**Committee of Experts on the Transport of Dangerous Goods
and on the Globally Harmonized System of Classification
and Labelling of Chemicals****Sub-Committee of Experts on the Transport of Dangerous Goods****Forty-seventh session**

Explosives and related matters:**review of tests in parts I and II of the Manual of Tests and Criteria****New design for the standard detonator in the Manual of Tests
and Criteria****Transmitted by the expert from Germany¹****Introduction**

Amended Appendix 1 to the Manual of Tests and Criteria

Figure A1.1: STANDARD DETONATOR (EUROPEAN)

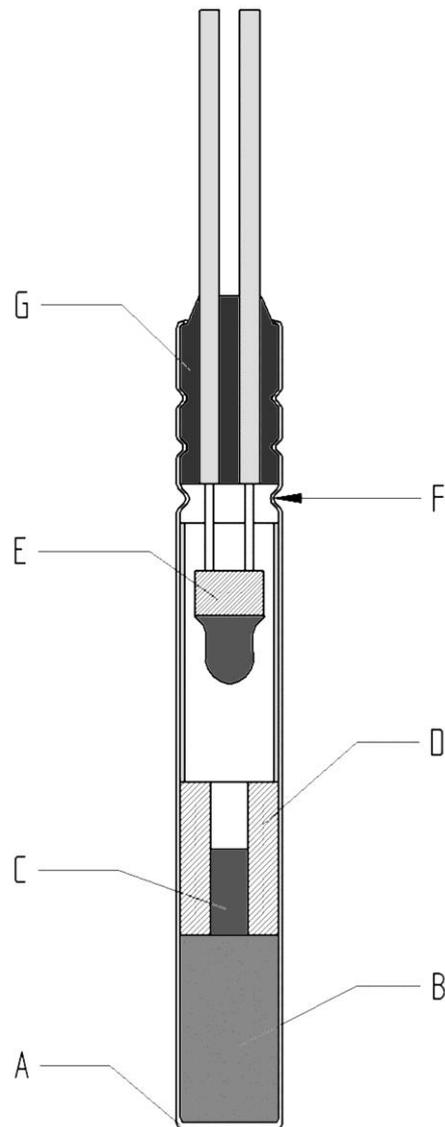
- (a) A discharge gap near the bridge wire to enhance electrostatic safety;
- (b) A solid steel tubing to contain the very sensitive primary charge between the fuse head and the secondary charge (NME-design); and
- (c) The use of environmentally friendly substances in the fuse head.

8. In Appendix 1 of the Manual of Tests and Criteria with the title "SPECIFICATIONS OF STANDARD DETONATORS" the Table and Figure A1.1, to which the table refers, shall be fully replaced with the information in the Annex to this working document. Figure A1.2 which refers to the US detonator is retained without changes.

According to the elements of the standard detonator indicated in Figure A1.1 by letters A-G the following specifications apply:

The blasting cap shall be hollow-drawn from copper with not more than 5% zinc, where an alloy is used. The cap shall have an outer diameter of $7.0 \text{ mm} \pm 0.1 \text{ mm}$. The wall thickness shall be $0.24 \text{ mm} \pm 0.05 \text{ mm}$. The thickness at the bottom of the cap shall be $0.42 \text{ mm} \pm 0.05 \text{ mm}$.

The secondary charge shall be PETN and with a mass of $0.60 \text{ g} \pm 0.01 \text{ g}$. The secondary charge is pressed into the bottom of the blasting cap and shall have no gaps or air spaces.

The primary charge shall be fully contained in the tube (D) and shall consist of not more than 0.10 g of a primary explosive (preferably lead-free). The primary charge usually will not fully fill the space inside the tube (D). It needs to be in direct contact to the secondary charge.

This tube acts as protection of the primary charge against fragments which could cause a sympathetic detonation. The length of the tube shall be 10-15 mm, the outer diameter shall be such to fit snugly into the detonator cap, the wall thickness of the tube shall be not less than 1 mm, and the inner diameter is typically not less than 2 mm.

The fuse head shall have a protection against electrostatic discharge. The fuse head charge shall contain not more than 50 mg of a primary explosive (preferably lead-free). The distance between the fuse head (E) and the tube (D) shall be in the range of 3-10 mm. The electric parameters of the bridge wire in the fuse head shall be of an electrically insensitive type. The no-fire current shall be 0.45 A (Ampere) or greater, the no-fire impulse shall be 8 mJ/Ohm or greater.

There shall be a narrow air gap ("spark gap") between the exposed lead wires of the fuse head (E) and the blasting cap (A). The plug (G) must leave room for a spark to the lead wires, and a crimping may be used to generate a fold to even further narrow the gap. The distance between the fuse head and the nearest metallic parts shall be sufficiently large, such that the spark gap is functional.

The plug tightly surrounds the lead wires and forms together with the crimping of the blasting cap (A) a tight closure of the blasting cap.

- Where the tube (D) is made out of sufficiently strong steel it “survives” the functioning of the detonator. I. e. it will stay intact and will not form fragments, which would be detrimental to the intended effect. The tube (D) shall not fragment upon functioning.

- Protection of the fuse head (E) against electrostatic discharge can be achieved in different ways. The fuse head may be surrounded by a plastic tubing, which fits without play inside the detonator cap (A). This can be done to generate a long path for a discharge between fuse head and cap. In Figure A1.1 such a plastic tube is indicated to show this to be a permissible variation. This plastic tube is optional and protection of the fuse head can also be achieved by conductive coating.

- Figure A1.1 shows a closing plug (G) with straight lead wires. Twisted lead wires within the closing plug are also common and irrelevant for the functioning or safety of the detonator. The plug (G) may extend outside the blasting cap (A), which is also irrelevant for the functioning. The plug (G), however, shall at minimum be aligned to the open end of the blasting cap (A).
